4291B-09A

## S E R V I C E N O T E

### Agilent 4291B RF Impedance/Material Analyzer

Part number changes for LCD

### COLOR LCD ASSY (E4970-65001) part:

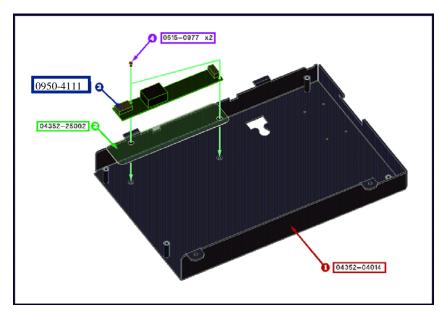
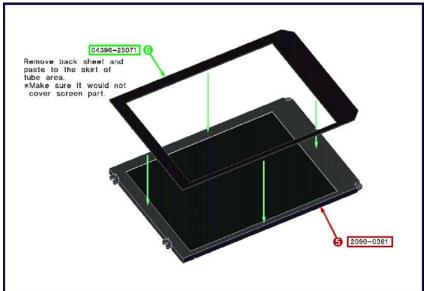
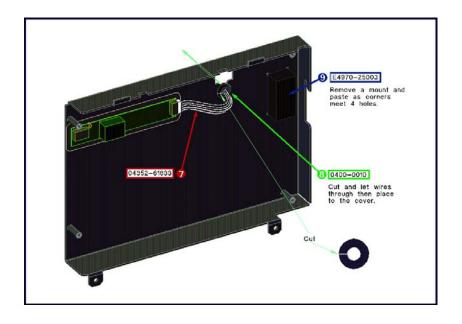
The LCD (P/N 2090-0574) used in the 4291B was obsoleted and replaced with a new LCD. When the LCD is defective, use new replacement LCD P/N 2090-0361 or LCD ASSY P/N E4970-65001.

The new LCD has different assembly size from old one and is used with a new inverter board for backlight. The LCD and GSP board are required for replacing the LCD depending on instrument serial number.

When replacing the LCD, use the appropriate replacement parts or assemblies for the instruments with serial numbers shown below.

Serial number	Part number	Qty Description
JP1KE00101 to JP1KE00166	E4970-65001 E4970-66554	COLOR LCD ASSY GSP BOARD (Part number changed on MAR 1998, see Service Note 4291B-01).
JP1KE00167 to JP1KE000709	E4970-65001	COLOR LCD ASSY
JP1KE00710 and Above	2090-0361	COLOR LCD
